N62578.AR.002564
NCBC DAVISVILLE
5090.3a

EMAIL REGARDING U S NAVY RESPONSE TO RHODE ISLAND DEPARTMENT OF
ENVIRONMENTAL PROTECTION COMMENTS ON THE FEASIBILITY STUDY FOR THE
SAMPLING AND ANALYSIS PLAN FOR SITE 16 NCBC DAVISVILLE RI

4/8/2010
U S NAVY

SOIL GAS INVESTIGATION FOR BUILDINGS IN THE EASTERN PORTION OF THE CVOC PLUME PROBLEM NO.5
 SAMPLING AND ANALYSIS PLAN TO SUPPORT FEASIBILITY STUDY FOR SITE 16
 FORMER NCBC DAVISVILLE FACILITY
 NORTH KINGSTOWN, RHODE ISLAND

CONTRACT NUMBER	
CTO WE51	
APPROVED BY	DATE
APPROVED BY	DATE
FIGURE NO.	REV
FIGURE 17-4	0

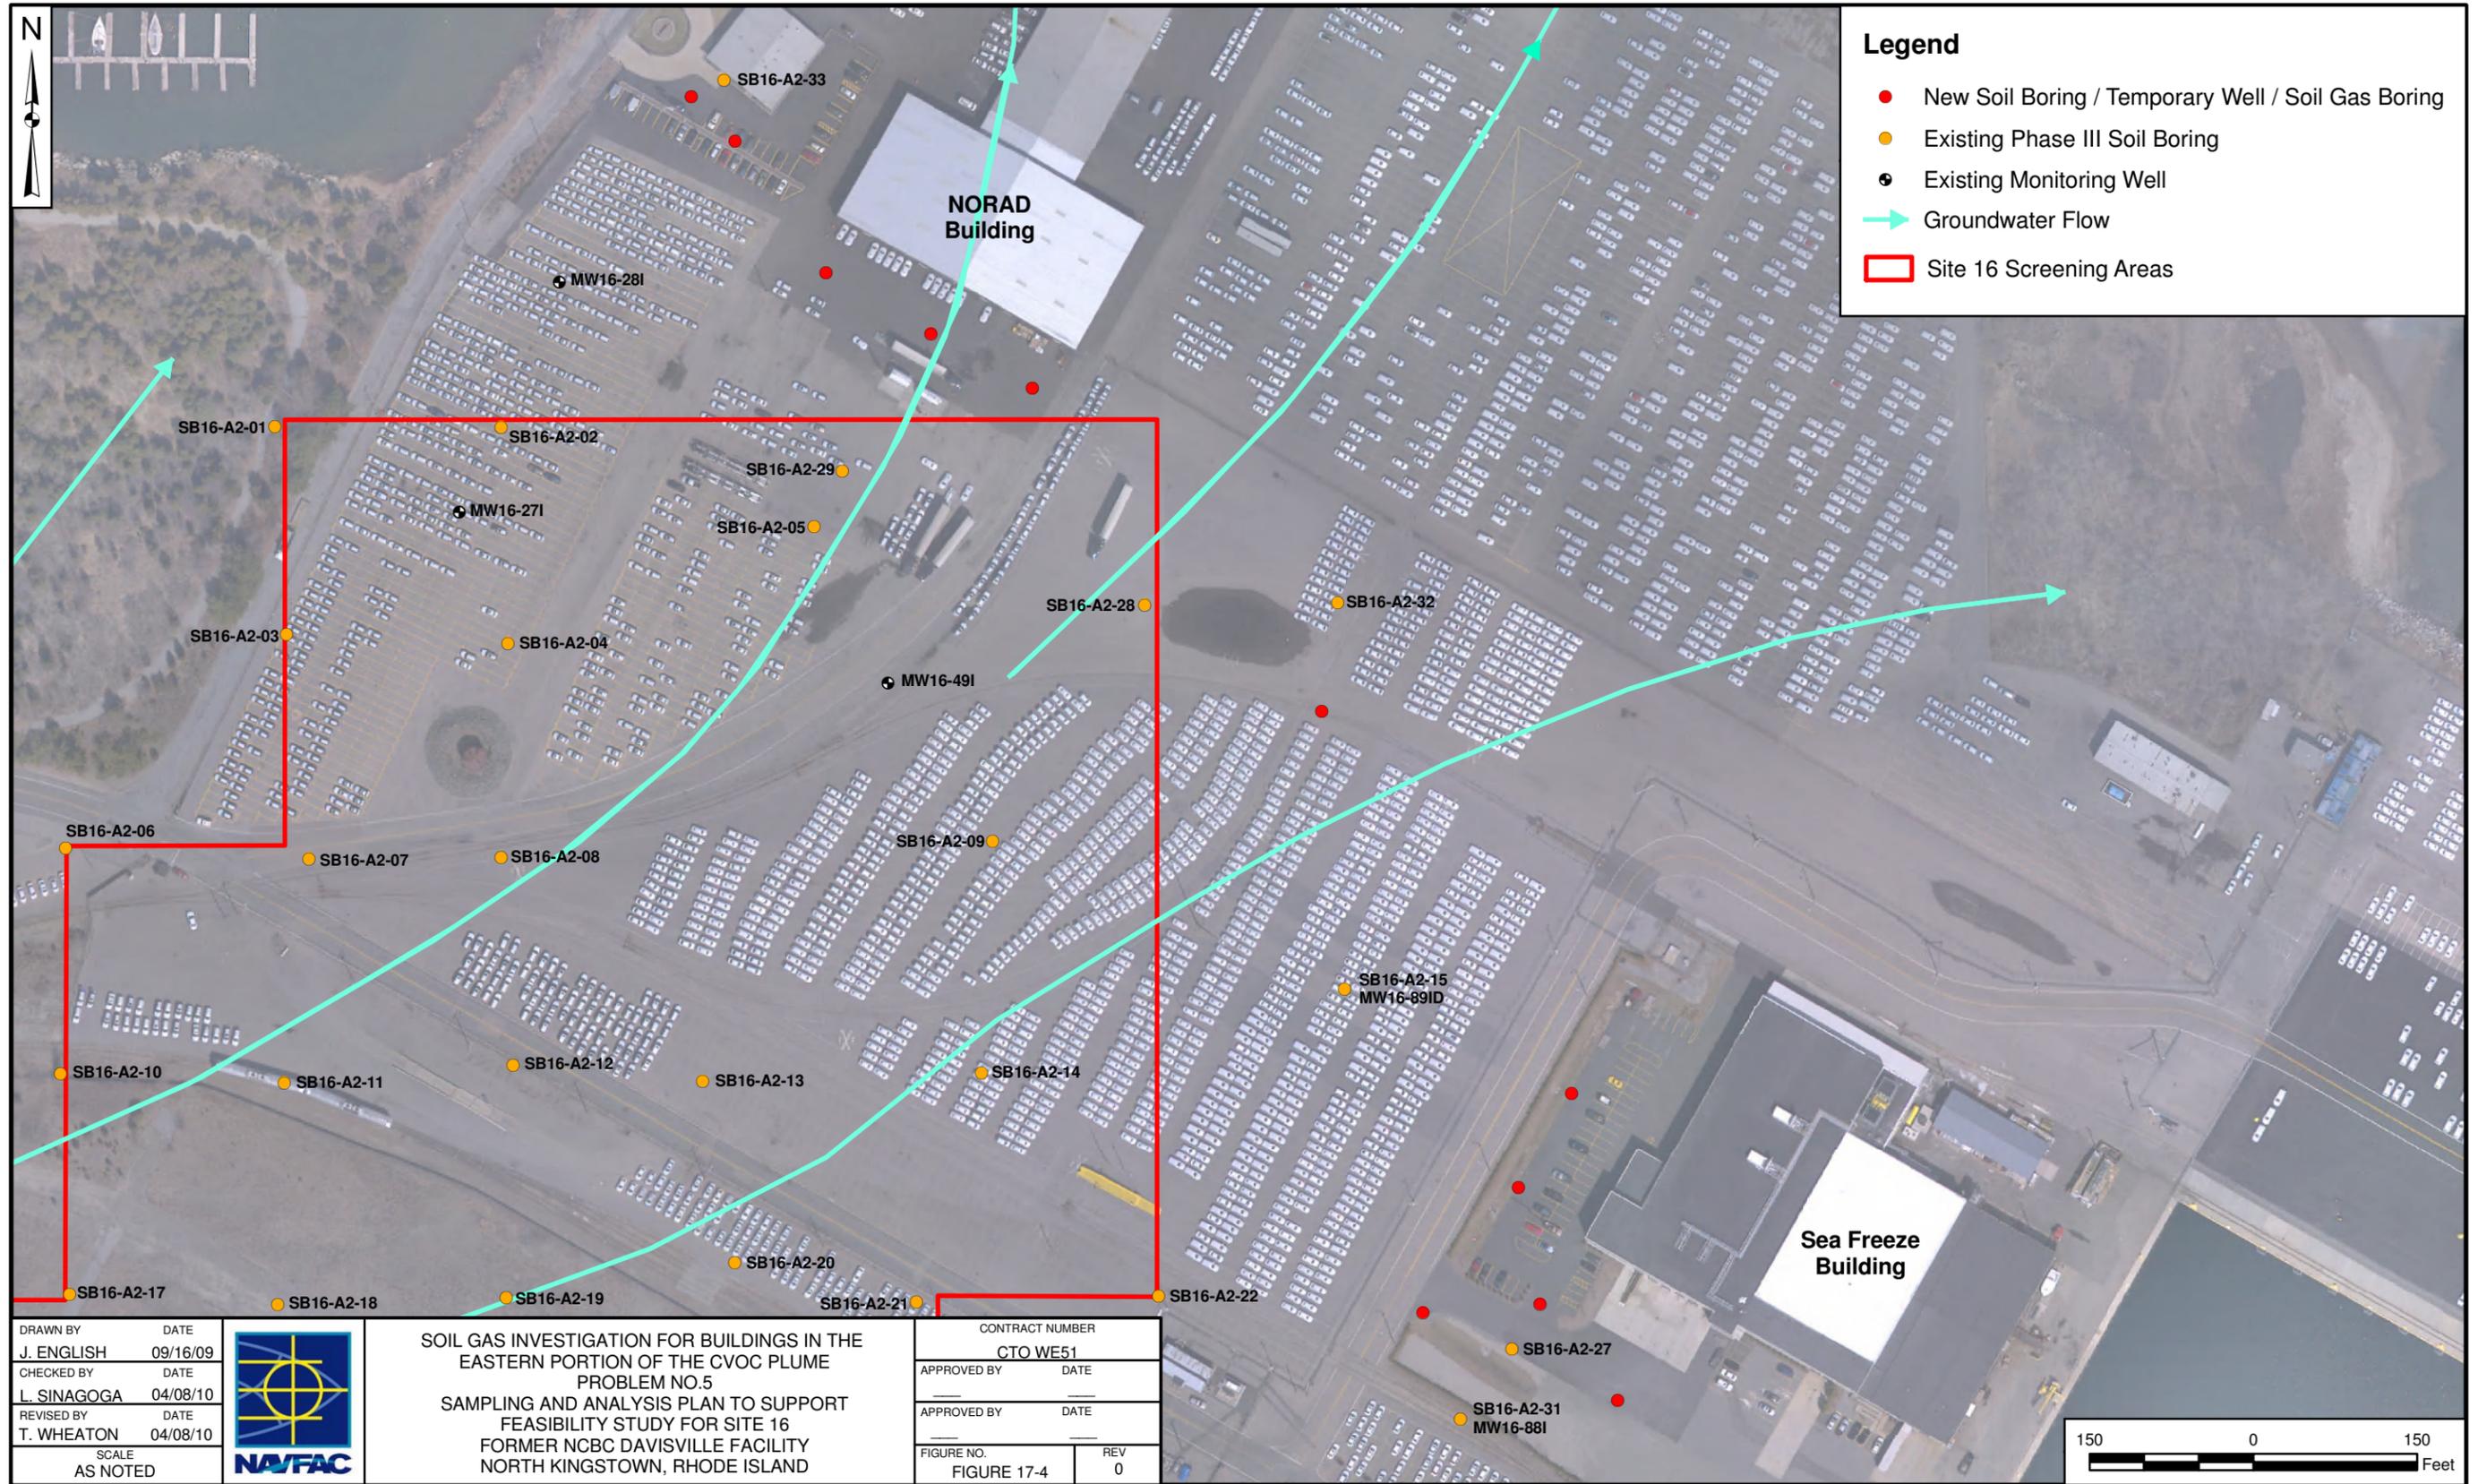
We appreciate your input on the response to comment process given the DSMOA funding issue that was recently resolved. We have incorporated your request (letter dated 5 April 2010) for an additional sample location between the Sea Freeze and NORAD buildings on the revised figure 17-4 (attached). This proposed sample location will adhere to the same rationale as the other proposed sample locations on the figure (direct push shallow groundwater/soil vapor) for Problem Statements 4 and 5. You will also observe that the original sample locations have been spaced closer together at the upgradient edge of each building. This was a result of an EPA/Navy conference call on 3/4/2010 for Problem Statement 5.
